UNITED STATES PATENT AND TRADEMARK OFFICE

Office Action Summary	Application No. 09/876,396	Applicant(s) KARIYAZAKI, SYUUICHI	
	Examiner Colleen A. Matthews	Art Unit 2811

DETAILED ACTION

Annotated Figure 14

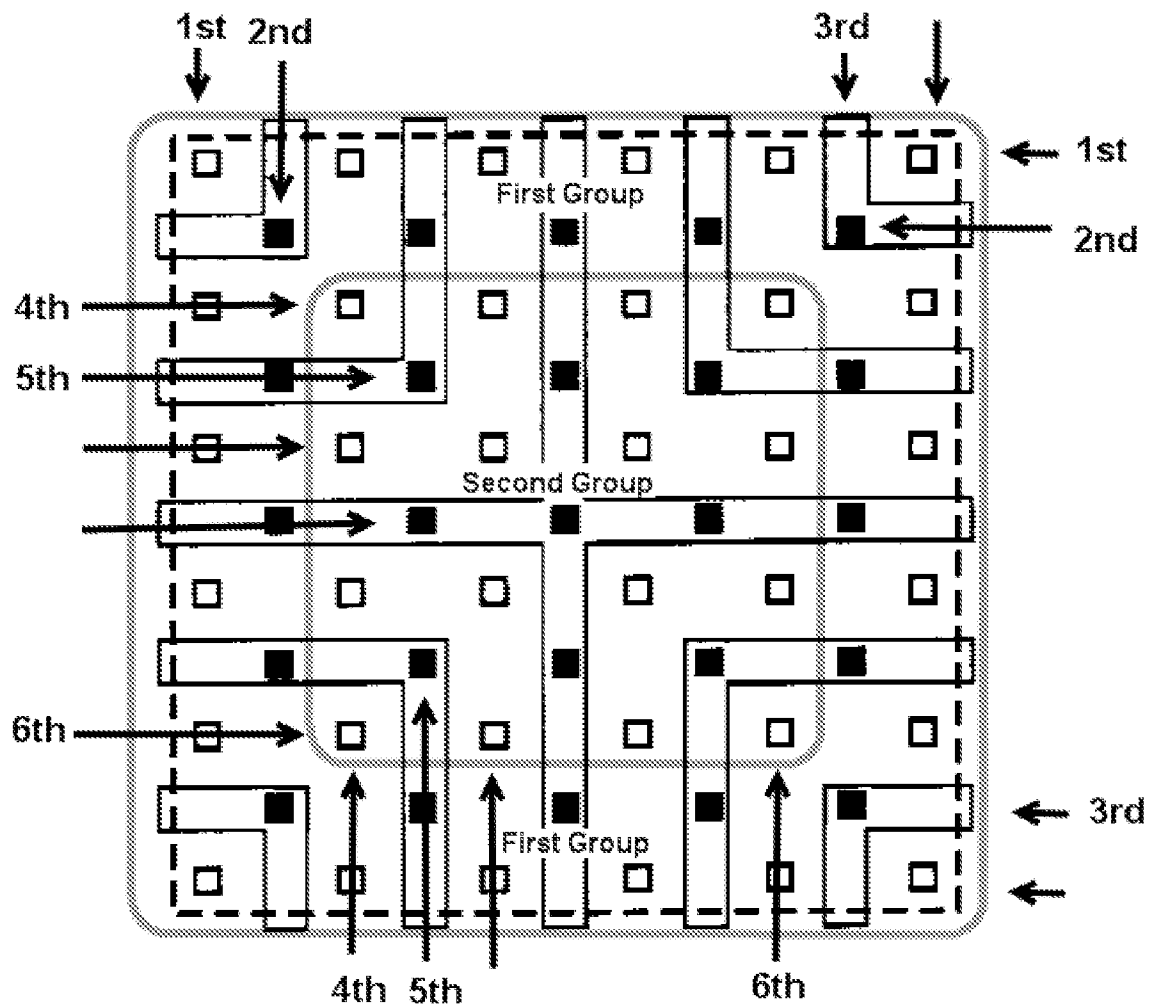
the interconnect pads forming a plurality of I/O cells including signal terminals, a portion of the I/O cells forming a first group (see annotated Fig 14, "+Shape (plus)", for example- first group considered as the outer area of pads labeled "First Group" Please note this is one sample presentation of the interpretation and others that read on the claim language are possible as well.) of I/O cells and another portion of the I/O cells forming a second group (see annotated Fig 14 "+Shape (plus)", for example- second group considered as inner area of pads labeled as "Second Group" Please note this is one sample presentation of the interpretation and others that read on the claim language are possible as well.) of I/O cells on an inner position of the mounting member with respect to the first group of I/O cells,

the first group of I/O cells including a first row, a second row, a third row, a first column, a second column and a third column of interconnect pads (see annotated Figure 14, this example interpretation includes 4 rows and 4 columns, showing

specifically an example of what could be considered as 1st, 2nd, and 3rd rows as well as the 1st, 2nd, and 3rd columns. Please note this is one sample presentation of the interpretation and other interpretations that read on the claim language are possible as well.) disposed to encircle a center of the mounting member, and

the second group of I/O cells including a fourth row, a fifth row, a sixth row, a fourth column, a fifth column and a sixth column of interconnect pads (see annotated Figure 14, this example interpretation has 7 rows and 7 columns, showing specifically an example of what could be considered as 4th, 5th, and 6th rows as well as 4th, 5th, and 6th columns. Please note this is one sample presentation of the interpretation and others that read on the claim language are possible as well) disposed to encircle a center of the mounting member (also col 11 lines 48—col 12 line 40),

the first group of I/O cells arranged in a first row, a first column perpendicular to the first row (see annotated Fig 14), a second row disposed on an inner position relative to the first row, and a second column that is perpendicular to the second row and disposed on an inner position relative to the first column (see annotated Fig 14, arrows indicate second rows and columns inner to first rows and columns)

the second group of I/O cells arranged in a fourth row, a fourth column perpendicular to the fourth row (see annotated Fig 14), a fifth row disposed on an inner position relative to the fourth row, and a fifth column that is perpendicular to the fifth row

and disposed on an inner position relative to the fourth column (see annotated Fig 14, arrows indicate fifth rows and columns inner to fourth rows and columns);

the first row, the second row, and the third row of the first group of I/O cells are parallel to one side of the semiconductor member (see annotated Fig 14),

the first column, the second column, and the third column of the first group of I/O cells are parallel to an another side of the semiconductor member(see annotated Fig 14),

the fourth row, the fifth row, mad the sixth row of the second group of I/O cells are parallel to the one side of the semiconductor member (see annotated Fig 14),

and the fourth column, the fifth column, and the sixth column of the second group of I/O cells are parallel to the another side of the semiconductor membe (see annotated Fig 14).

Regarding claim 10, Moresco discloses a semiconductor device, wherein at least one of the first group (see annotated Fig 14- first group) and the second group (see annotated Fig 14- second group) includes an outer group (see annotated Fig 14-

first group) and inner group (see annotated Fig 14-second group) disposed on the inner position of the mounting member with respect to the outer group (see annotated Fig. 14-first group).
